Department of Energy
Carlsbad Field Office
P. O. Box 3090
Carlsbad, New Mexico 88221

This purpose of this letter is to request approval from the Environmental Protection Agency (EPA) regarding a proposed change in the utilization of Panel 1 at the Waste Isolation Pilot Plant (WIPP). The proposed change will allow the DOE to determine the optimum waste configuration in each room at the time of emplacement based on considerations of worker safety, operational efficiency and cost. We previously briefed your agency regarding this subject on June 28 and December 13, 2000.

PANEL 1 UTILIZATION ANALYSIS FOR THE WASTE ISOLATION PILOT PLANT

Figure 1. Closure of Empty Storage Room (Morgan, 1987)

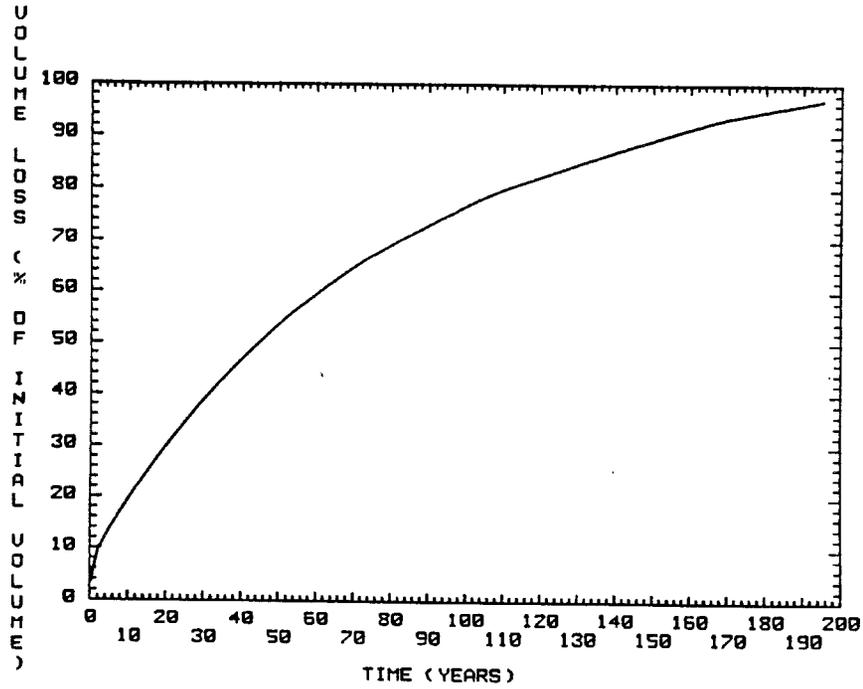
Room closure can be quantified by geomechanical modeling. Response of the underground is conventionally modeled using the finite element method (FEM). Many pertinent analyses of waste rooms have been performed (e.g., Morgan, 1987, Callahan and DeVries, 1991 and Stone, 1997). Morgan's analysis of closure of an empty single room using SANCHO (a precursor of SANTOS) estimated total room closure in 195 years (Figure 1), without simulating the effects of roof collapse and floor heave. The analyses by Stone used the FEM code SANTOS. Figure 2 is a plot referenced by Stone, which illustrates room closure rates (although this particular calculation simulates the presence of WIPP waste in the room). Porosity is reduced to about 8% in approximately 100 years. As salt-backfilled rooms or empty rooms approach total closure, permeability will reduce asymptotically to values equivalent to those of intact salt ($K < 10^{-19} \text{ m}^2$). This estimate of re-consolidated salt permeability (K) derives from a relationship between permeability and density, which was developed for the shaft seal system design (Sandia, 1996).

If disposal rooms are left open and unsupported or roof bolted, creep closure and structural response will include floor heave and roof fall. With creep closure the empty (no WIPP waste) room would close around disaggregated material derived from the damaged rock in the roof, floor and ribs. Halite consolidation would then be the primary mechanism of porosity reduction. Callahan and DeVries calculated the closure of backfilled rooms, which are equivalent in many ways to an empty room filled with debris. They calculated mean stress development for rooms containing various backfill materials, which usually exceeded 10 MPa in 200 years. Salt debris subjected to such stress conditions would be well consolidated. Evidence from many studies indicates re-consolidation is effective and rapid (Mellegard et al., 1998) under conditions of modest mean stress (of the order of 5 MPa). Thus, the closing room would provide ample stress to reconsolidate the salt aggregate.

Figure 3. Disposal Room Volume Reduction when Back-filled with Crushed Salt.

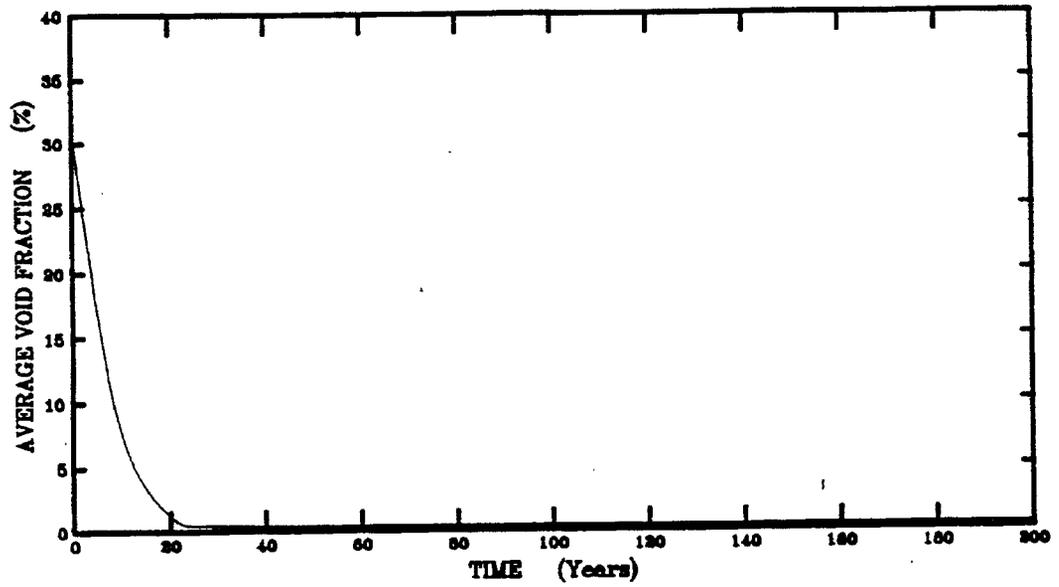
If rooms in Panel 1 were filled with mined salt, the granular salt would reconsolidate and reduce porosity and permeability. As depicted in Figure 3, creep closure and the natural healing mechanisms of crushed salt would tend to eliminate void space. The relatively high mean stresses calculated by Callahan and DeVries (greater than 10 MPa) ensures the granular salt would have porosity less than 5% in a very short time. Based on the permeability/density relationship noted earlier (Sandia, 1996), this range of consolidation equates to a permeability less than or equal to 10^{-18} m^2 . Eventually, in a few hundred years, permeability will return to values equivalent to intact salt ($K < 10^{-19} \text{ m}^2$). These porosity and permeability values are estimated from a body of experimental work supporting the compliance shaft seal design report (Sandia, 1996), and indicate that both permeability and porosity of rooms backfilled with mined salt would become much lower than the value of typical waste rooms. Behavior of rooms left empty would mimic rooms back-filled with crushed salt, because the salt debris is analogous to salt back-fill. The requisite closure for re-consolidation would ensue within decades.
